MEMORANDUM

To: The Design Advisory Board
From: Mary O'Neil, AICP, Senior Planner MO.
RE: ZP 15-0079CA
Date: September 23, 2014

File: ZP 15-0079CA
Location: 281 Flynn Avenue
Zone: RL **Ward**: 5
Date application accepted: July 16m 2914
Applicant/ Owner: Sandra Vishnevsky
Request: Add second story to existing single family home.

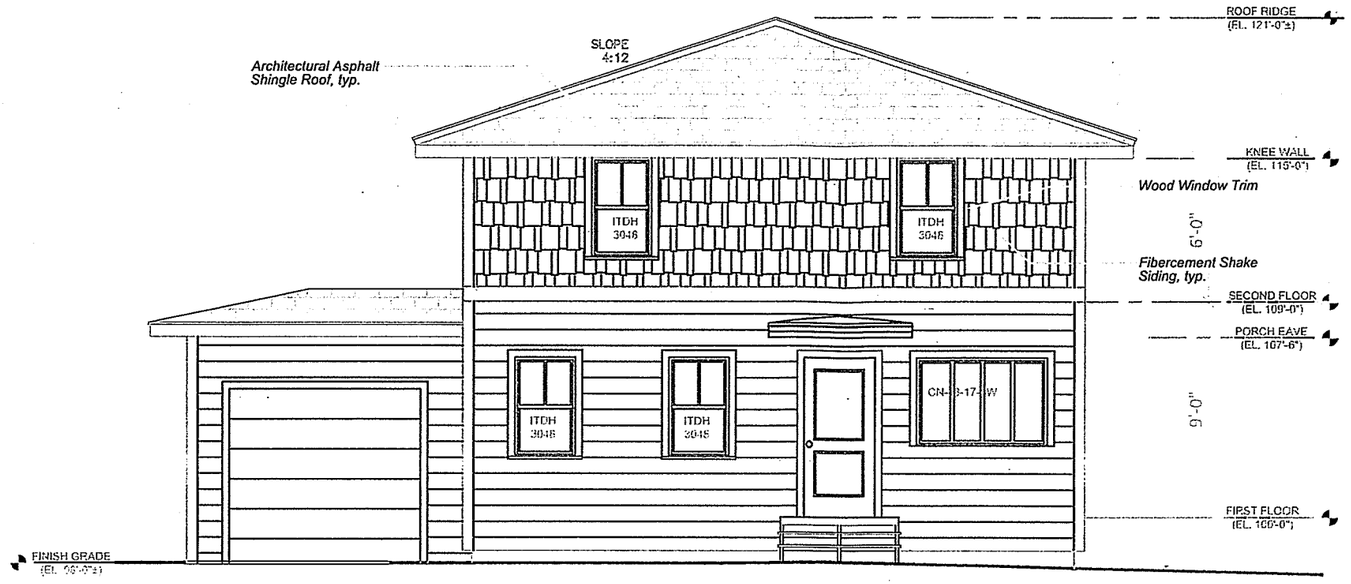
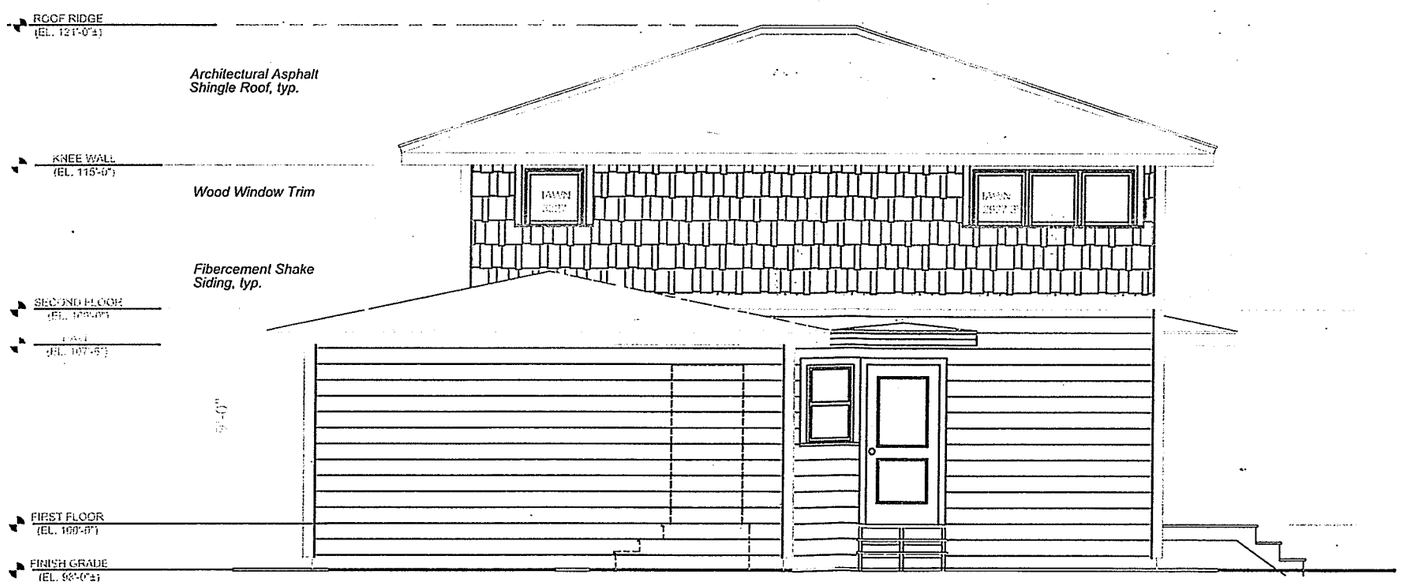
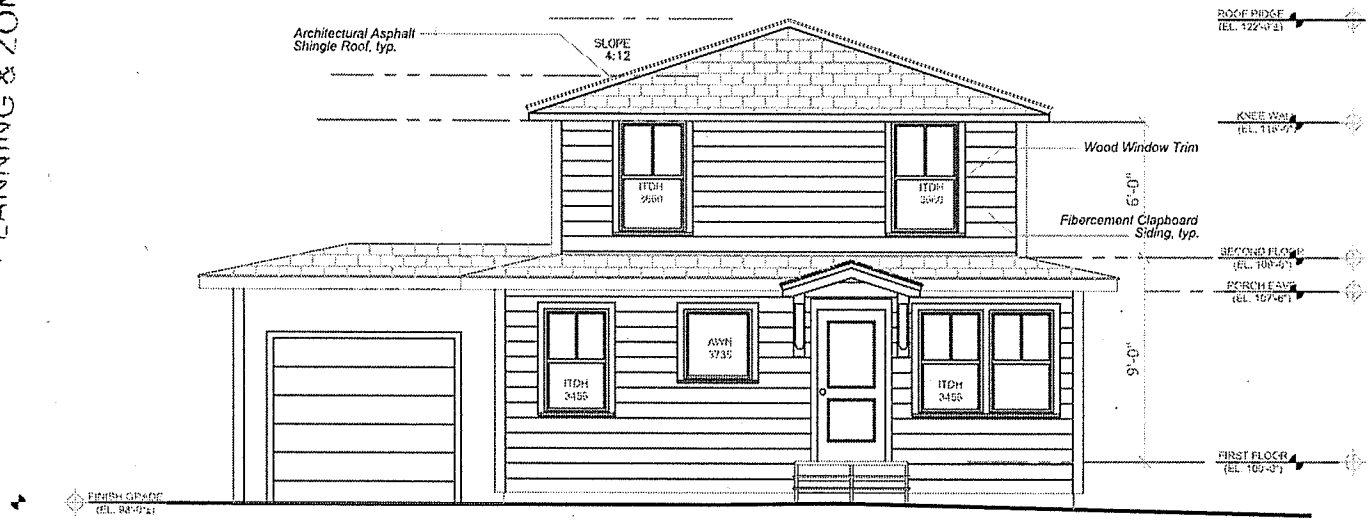
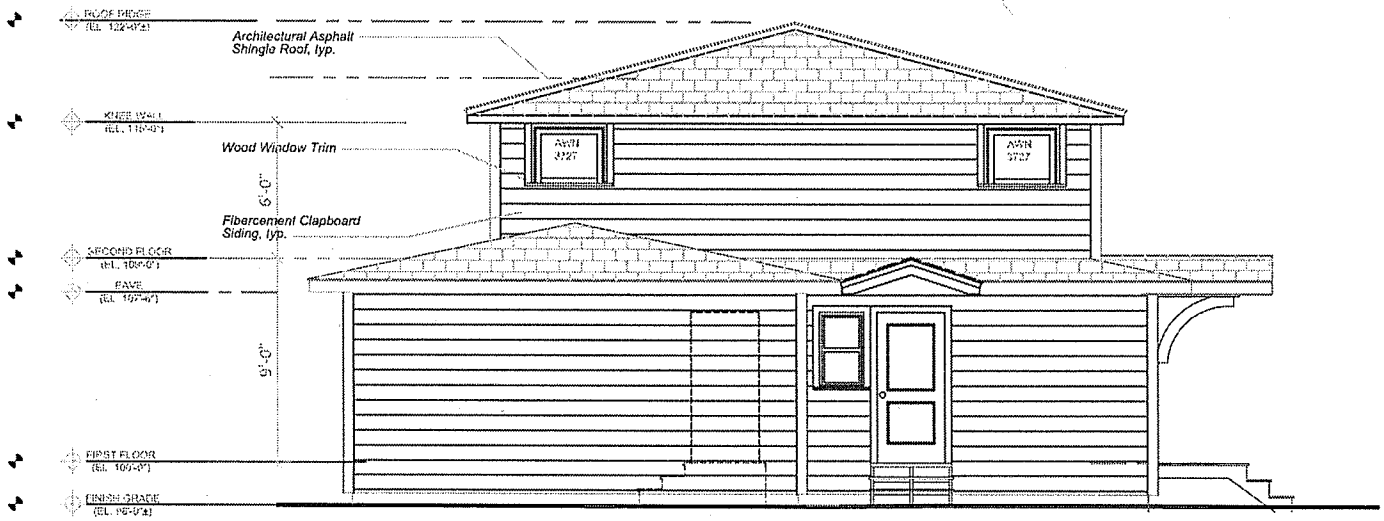
- Enlarge 2nd floor eaves to match depth of 1st floor eaves.
- Reconfigure front 2nd floor windows reducing their size and height
- Retain bow window
- Eliminate the gable porch roof – shed okay.
- Second floor siding change to shingle is acceptable.
- 2nd floor fascia should be the same as first floor fascia.

Revised plans illustrate the reconfiguration of front 2nd floor windows, reducing their size and height. The bow window is retained. The porch roof is how a hip roof and the plans define the siding change to shingle on the 2nd floor.

The disparity lies in the complete elimination of the first floor eave line, and expansion of the 2nd floor to fit squarely over the first floor. Therefore, the first and 6th recommendation relating to the relationship between the first floor eave and 2nd floor is not reflected. The floor plan reflects the expanded 2nd story space.
